# BUILDING CODE OF AUSTRALIA 2019 COMPLIANCE ASSESSMENT REPORT

MIXED USE DEVELOPMENT

167 NORTHUMBERLAND STREET, LIVERPOOL

REPORT NO. ► PROJECT 1423-195-REV 1

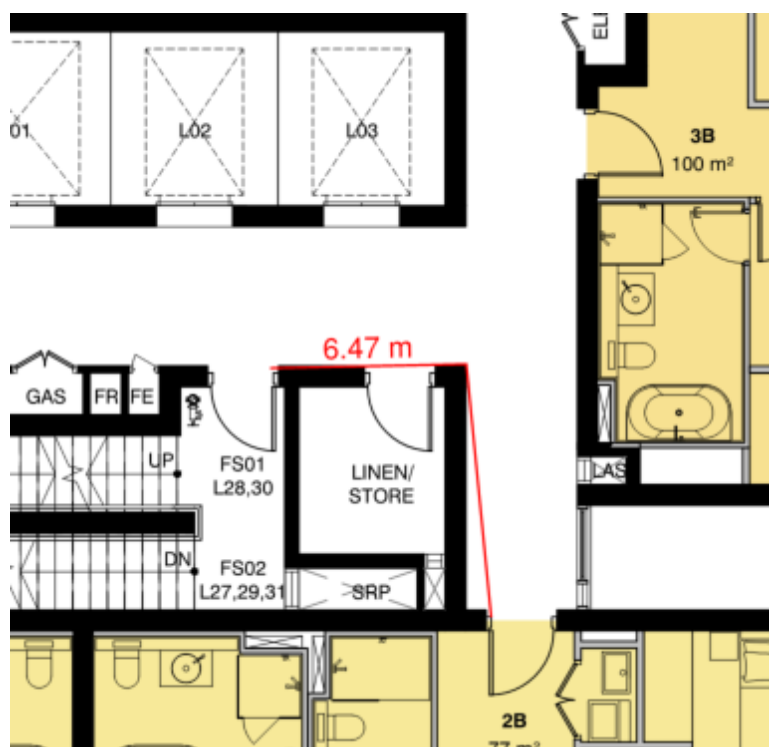
- Level 5-7 – Eastern SOUs: Travel distance to an exit or a point of choice exceeds 6m (maximum being 8m).

Either update plans to reflect DtS compliance or a performance solution is to be developed by a Fire Engineer for all the above issues.

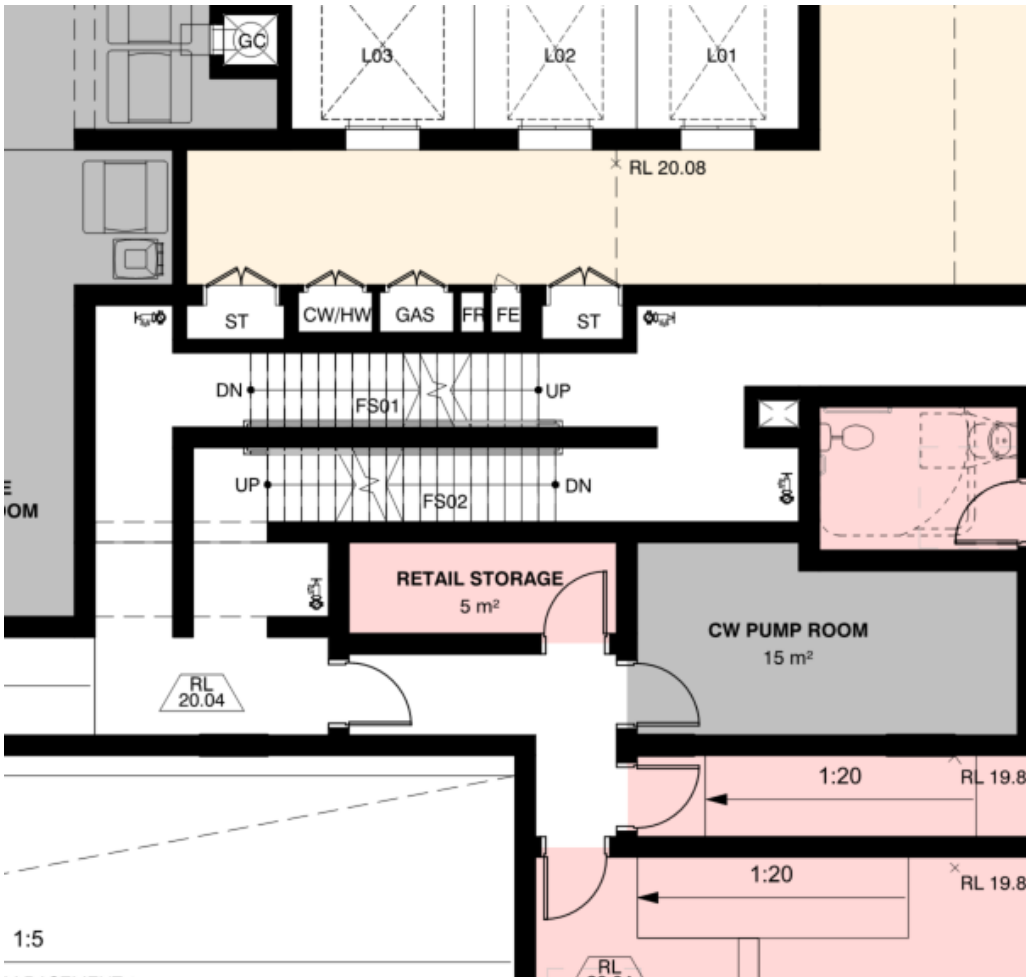
- Level 8 – Eastern SOUs: Travel distance to an exit or a point of choice exceeds 6m (maximum being 8m).

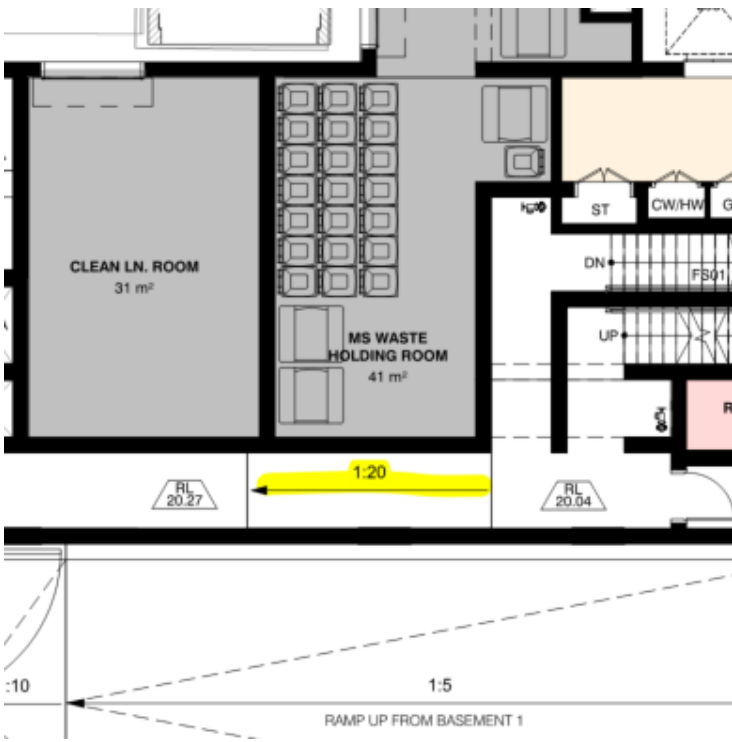
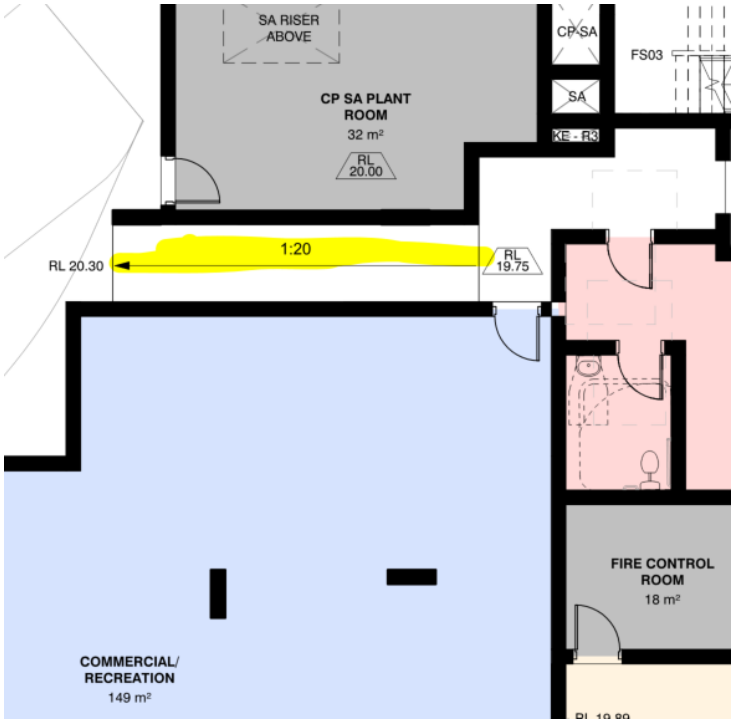
- Level 9 to 26 – Eastern SOUs: Travel distance to an exit or a point of choice exceeds 6m (maximum being 8m).

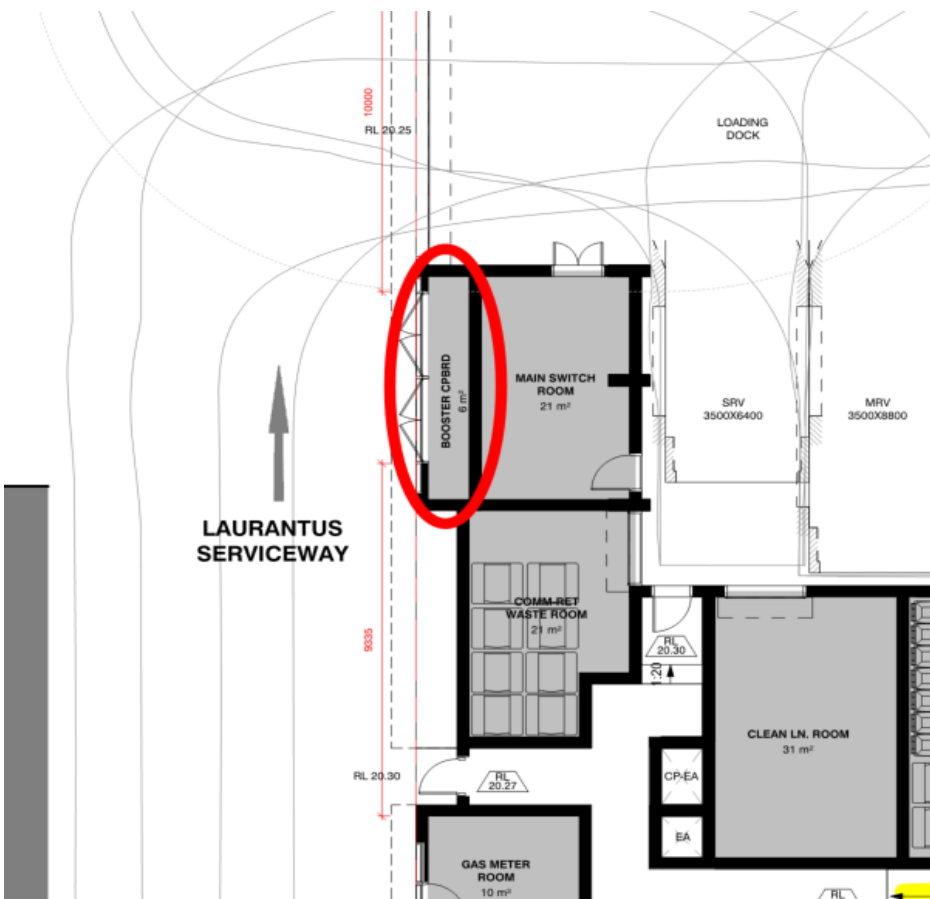
- Level 27 to 31 – Eastern SOU: Travel distance to an exit or a point of choice exceeds 6m (maximum being 7m).

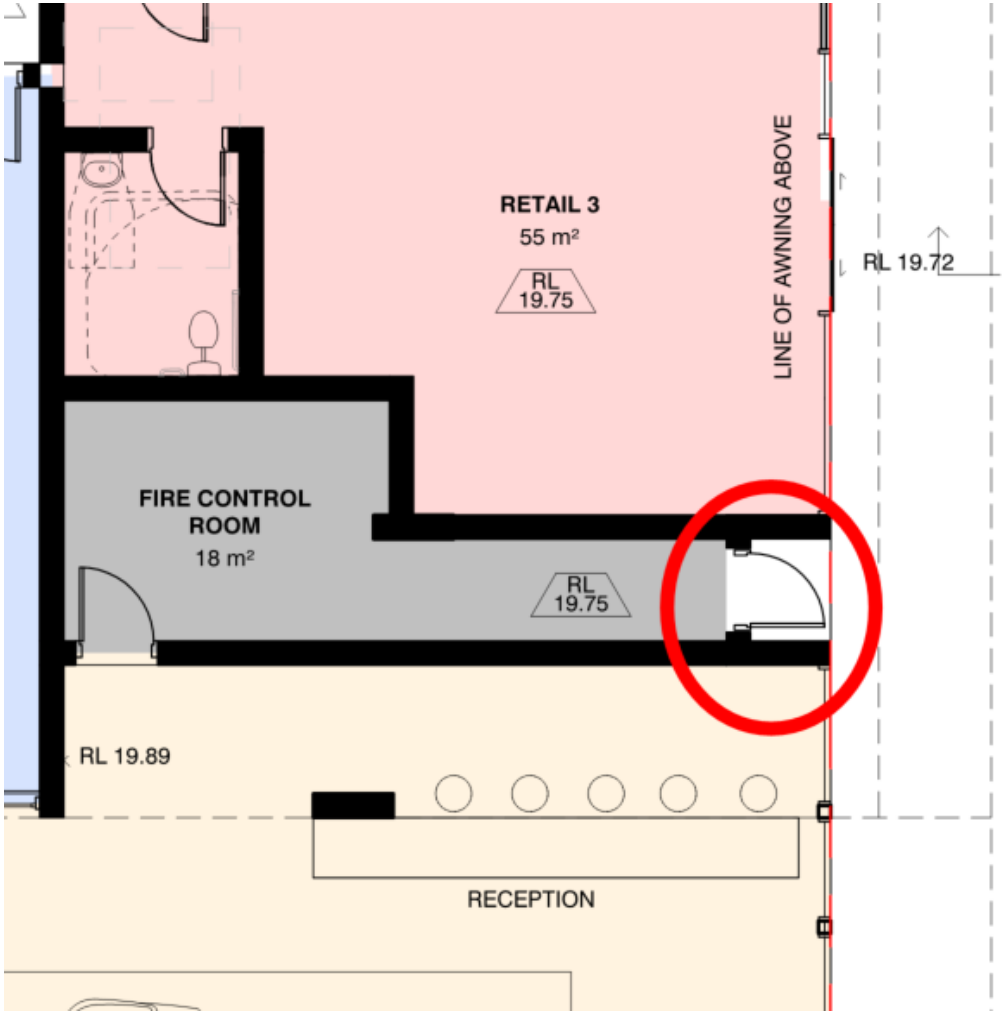
BCA Clause / NOTES	Deemed-to-Satisfy Provision to be addressed / NOTES
<p>E1.5</p> <p>Sprinklers</p>	<p><b><u>DTS non-compliance</u></b></p> <p>The sprinkler valve room in accordance with Spec E1.5 is required to be detailed.</p> <p><i>Full Hydraulic Services Design Certification and details must be incorporated into the construction certificate specification.</i></p>
<p>E1.6</p> <p>Portable fire extinguishers</p>	<p><b><u>DTS non-compliance</u></b></p> <p>The location of the proposed portable fire extinguishers is greater than the required 10m from the SOU entry door to the south-western SOU entry doors on the residential levels as below shown:</p>  <p><u>Level 4</u></p>

**Details demonstrating compliance with this clause must be incorporated into the construction certificate plans / specification including the proposed location of the extinguishers to serve the portions of the building other than the Class 3 portions.**
